UNITED STATES PATENT AND TRADEMARK OFFICE

10/552,593

Office Action Summary	Application No. 10/552,593	Applicant(s) MOMMA ET AL.	
	Examiner GERARD T. HIGGINS	Art Unit 1794

DETAILED ACTION

Applicants' attention is drawn to their Figure 3 and Figure 5 of Dang.

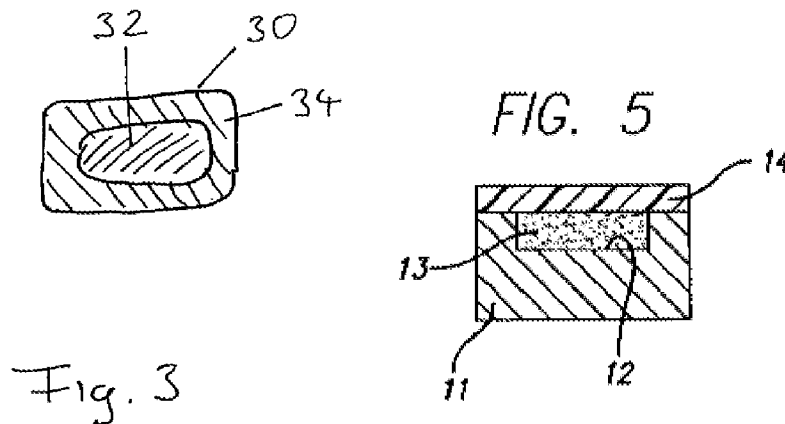
Applicants argue on page 7 of their Remarks that Figure 3 of the current specification and Figure 5 are "clearly differentiable" and that the cover layer of Dang does not form a core filled wire with the comparatively radiopaque material.

again respectfully disagrees with applicants' arguments and notes that Figure 3 of the current invention and Figure 5 of Dang are not "clearly differentiable" as suggested.

The Examiner argued in the previous Office action mailed 10/29/2008 and has restated in this rejection that the tube stock **11** and the sputtered coating **14** *combined* read on applicants' cover layer **34**. The Examiner maintains that although the cover layer of Dang is formed by a different process, i.e. forming grooves **12**, filling with radiopaque material **13** and covering over with the sputtered coating **14**, the Examiner deems the cover layer (**14** and **11**) has the same resultant structure as a hollow wire into which the radiopaque material fills the core thereof as claimed. Although the tube stock **11** and the sputtered coating **14** are shown to be distinct materials in Figure 5 of Dang, when the coating **14** of Dang is sputtered it will form a single material with the tube stock **11** as the two elements are comprised of the same material. This Examiner deems that this reads on applicants' "core filled wire," and applicants' arguments have not overcome this *prima facie* case.
